Groundwater Transfer Review Summary Form

Transfer/PA # T- <u>14252</u>				
GW Reviewer <u>Dennis Orlowski</u> Date Review Completed: <u>December 20, 2023</u>				
Summary of Same Source Review:				
☐ The proposed change in point of appropriation is not within the same aquifer as per OAR 690-380-2110(2).				
Summary of Injury Review:				
☐ The proposed transfer will result in another, existing water right not receiving previously available water to which it is legally entitled or result in significant interference with a surface water source as pe 690-380-0100(3).				
Summary of GW-SW Transfer Similarity Review:				
\Box The proposed SW-GW transfer doesn't meet the definition of "similarly" as per OAR 690-380-2130.				
This is only a summary. Documentation is attached and should be read thoroughly to understand the

Transfer Application: T-14252

Application T-14252 Willamette Tree Wholesale T6S, R3W, Section 13

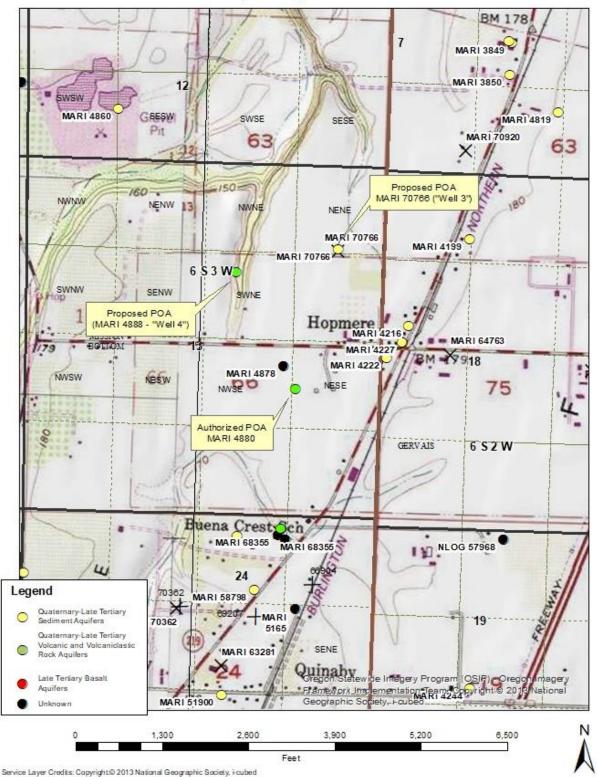
4.	a) Will this proposed change, at its maximum allowed rate of use, likely result in an increase in interference with another ground water right ?
	Yes No Comments: Relative to the authorized POA (MARI 4880) location, the locations for the two proposed POA (MARI 70766 and MARI 4888) are not relatively nearer to any known groundwater right. Furthermore, none of the area's wells fully penetrate the alluvial aquifer system in this area, estimated to be about 500-700 feet thick (Gannett and Caldwell, 1998), and thus are not subject to injury determinations. Nonetheless, the performance of wells in this area (e.g., specific capacity value and reported)
	well yield for MARI 58798) indicate a very prolific Willamette Aquifer system that should help mitigate any potential well interference effects not identified in this review.

5.	a) Will this proposed change, at its maximum allowed rate of use, likely result in an increase in interference with another surface water source ? Yes No Comments: All three wells are located from ~1.2 to 1.5 miles to the nearest perennial stream reach (Patterson Creek). Although proposed POA MARI 70766 is
	about 2100 ft nearer to this stream relative to authorized POA MARI 4880, the actual overall distances suggest that it is not likely the proposed use will result in an increase in interference with this surface water source.

7.	What conditions or other changes in the application are necessary to address any potential issues identified above: <u>None</u>
8.	Any additional comments: None
Daf	lower and
